Final Environmental Impact Report Volume IV - Response to Comments/Errata

South Shores Church Master Plan City of Dana Point

SCH No. 2009041129

**RESPONSE TO COMMENTS
AND ERRATA**

FIGURE 1

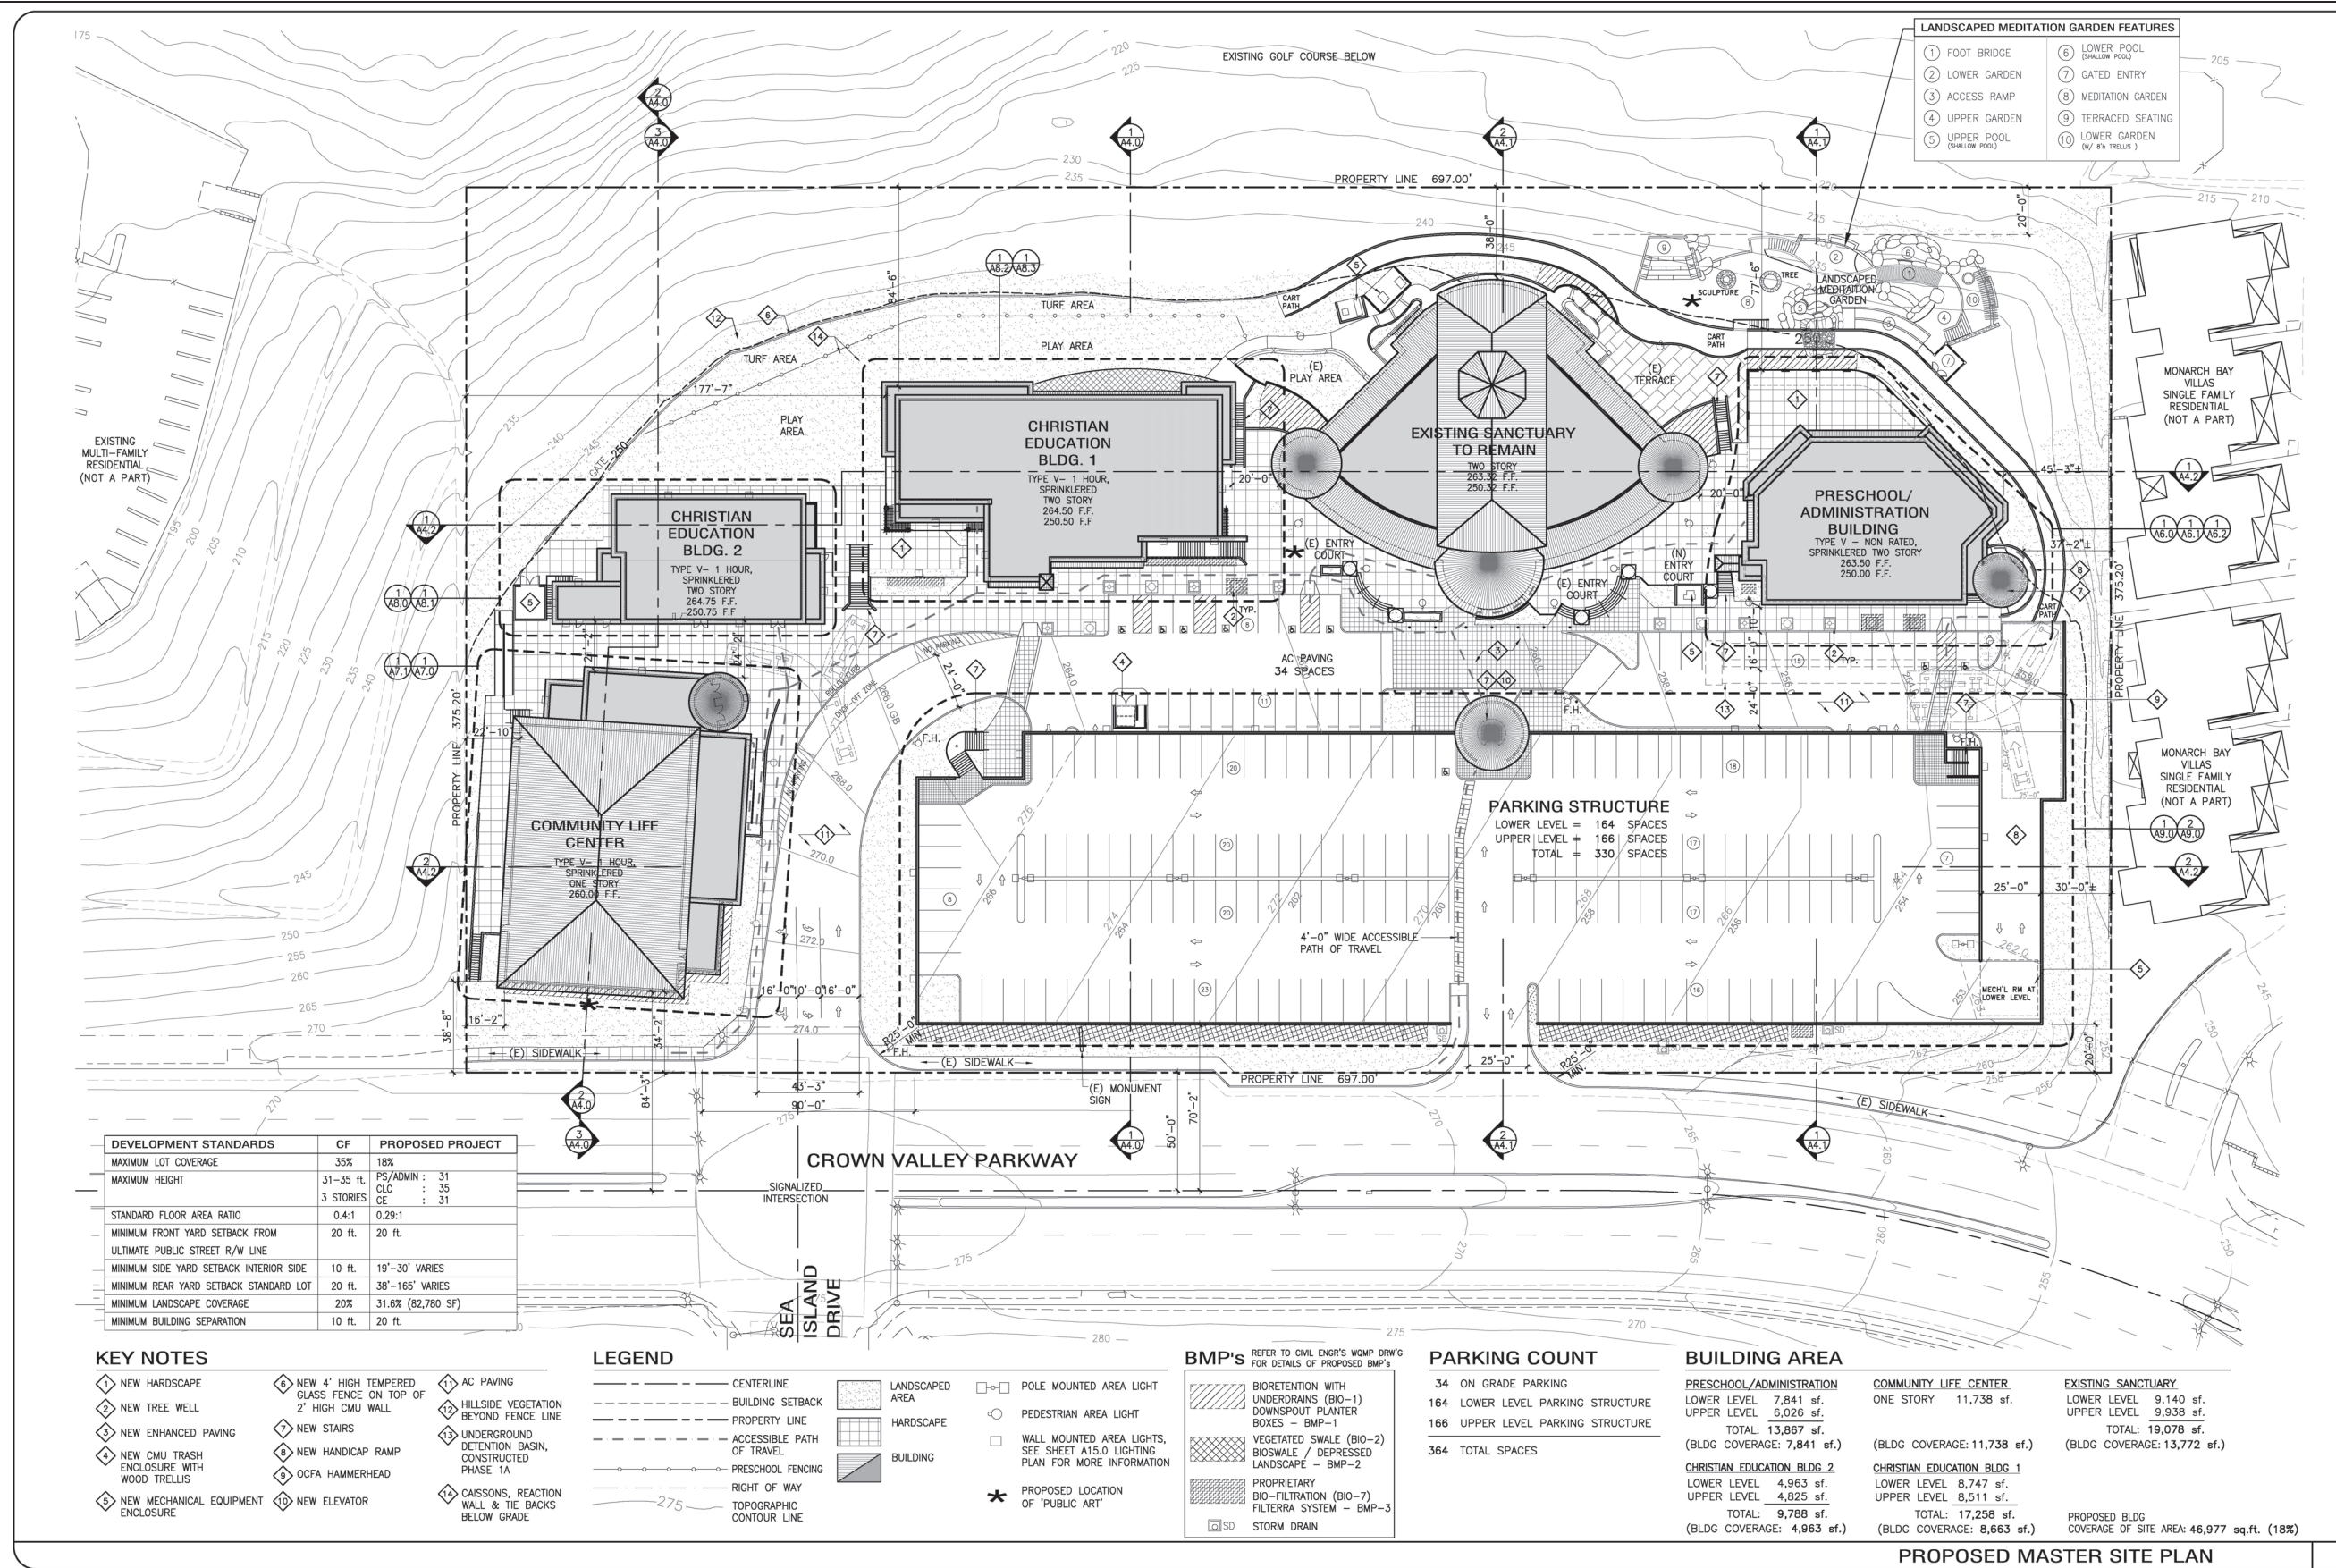
During the public comment period, many comments were made raising questions whether the parking structure should be permitted to be constructed as part of the final phases. Many of those making such comments argued (without any substantive evidence) that the Applicant would forego the parking structure due to its cost once the other project phases were completed.

In response to comments requesting that the parking structure be constructed sooner in the Master Plan, at the request of the City the Applicant has modified the construction phasing of Alternative 2. However, the proposed revisions to Alternative 2 will not materially or significantly alter the structures, uses, or activities associated with the proposed Master Plan. Unless specifically noted below, the size and location of all buildings, parking, and other features included in each construction phase would remain the same as Alternative 2 (refer to Figure 1 for a revised version of the site plan showing the location of the various design features associated with this revision to Alternative 2). Thus, the proposed project's environmental impacts, as set forth in the Draft EIR will remain the same and/or will be reduced. The proposed revisions to Alternative 2 do not raise any significant new information that would otherwise require re-circulation of the Draft EIR.

Additionally, in response to comments and concerns raised by some of the residents on Pompeii Drive in the Monarch Bay Villas, the proposed Landscaped Meditation Garden on the southeast corner of the project site would be moved approximately 30 feet further north from its previously proposed location under Alternative 2. No net increase in grading would be required to accommodate the relocation of the Landscaped Meditation Garden.

V-ditch from ESA near Point Monarch

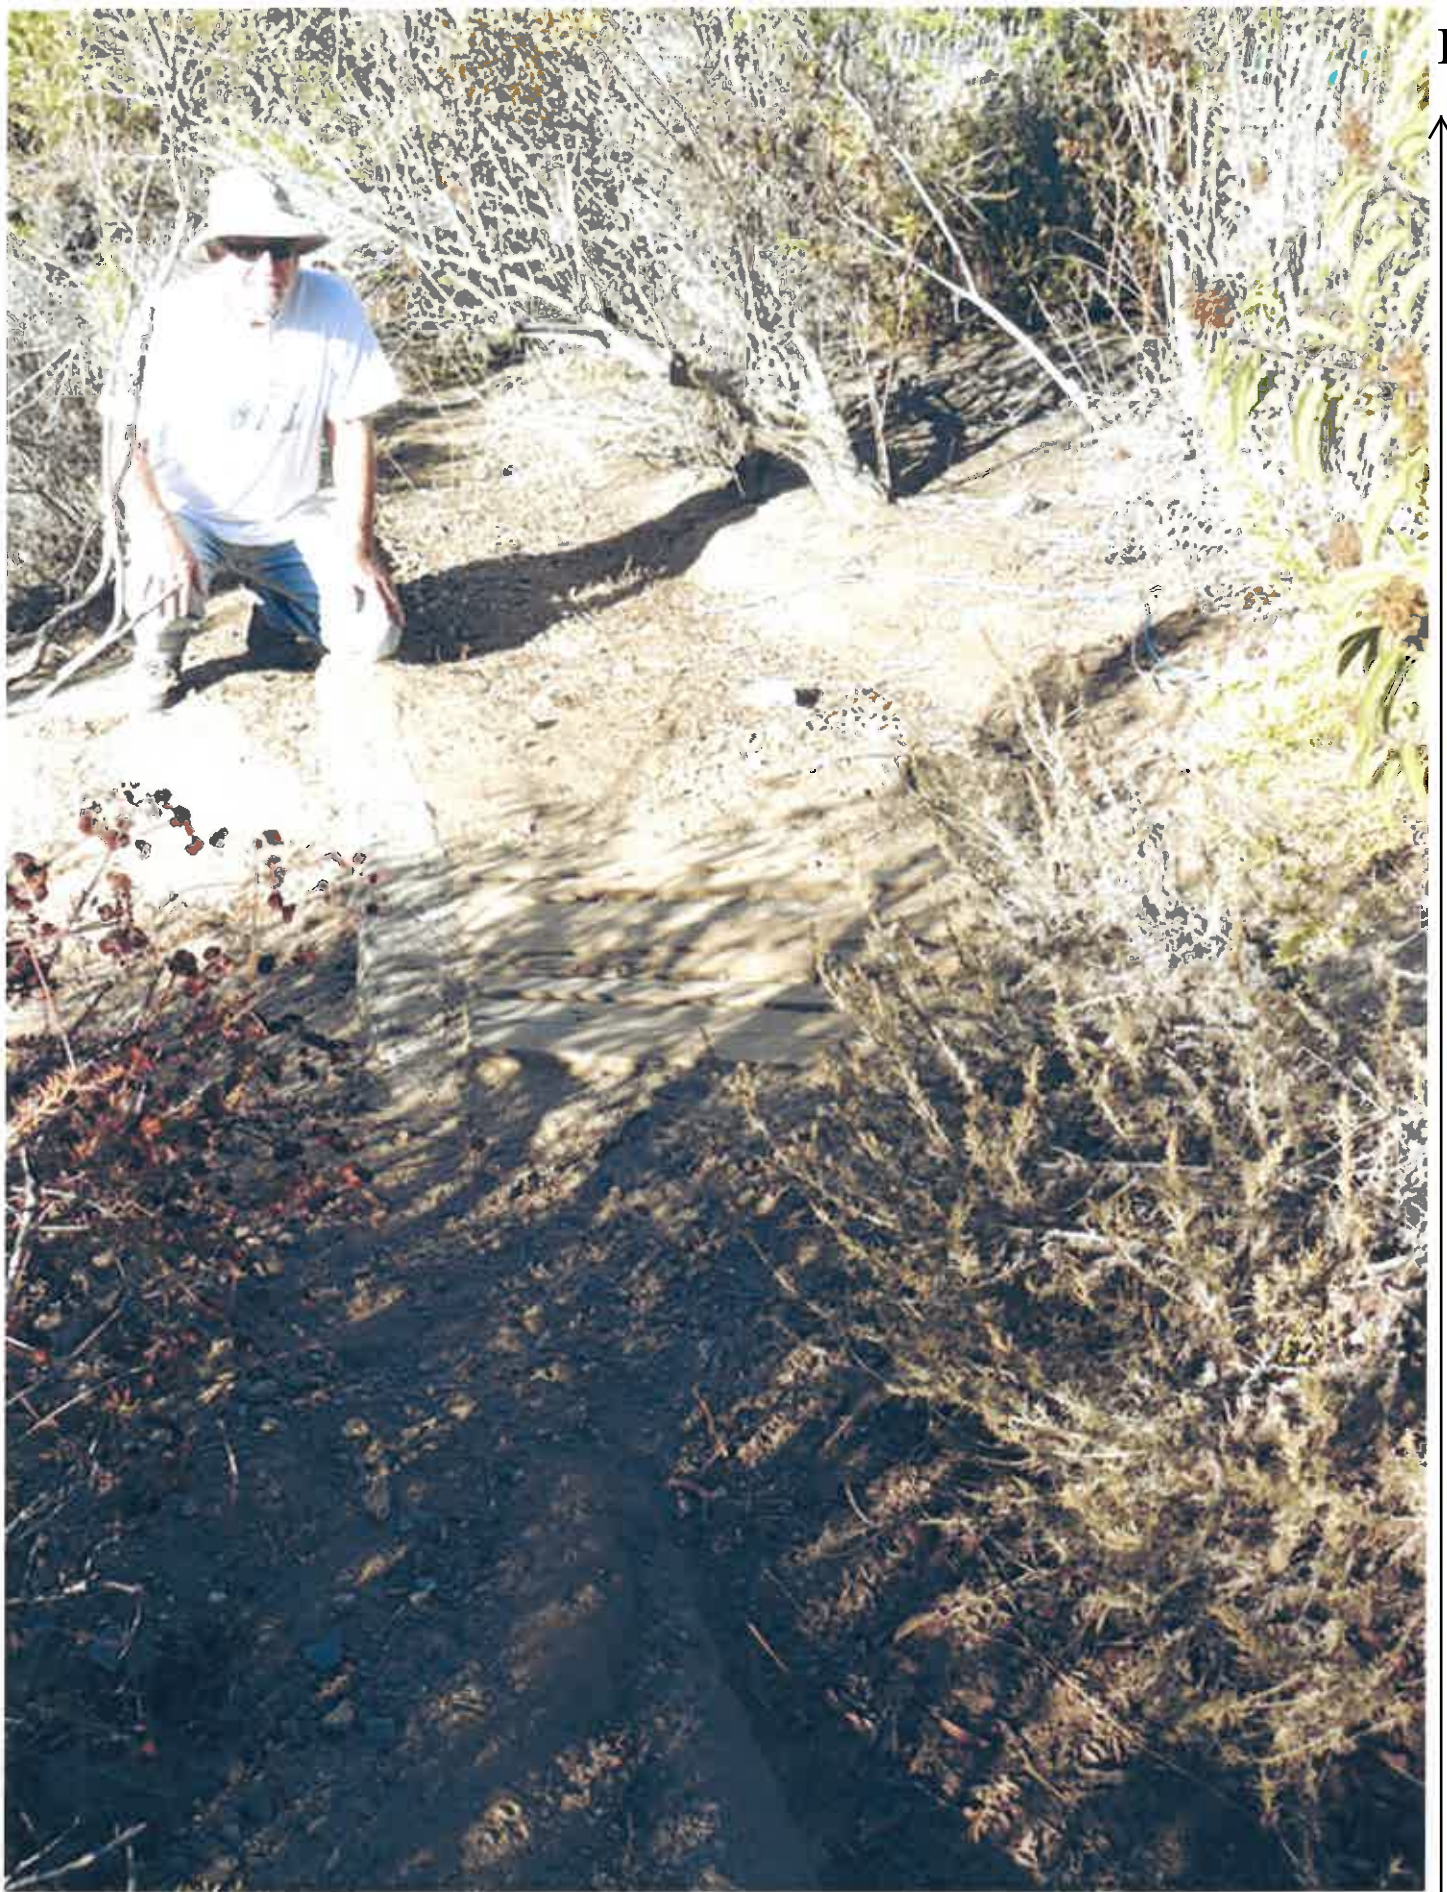
I-12-14
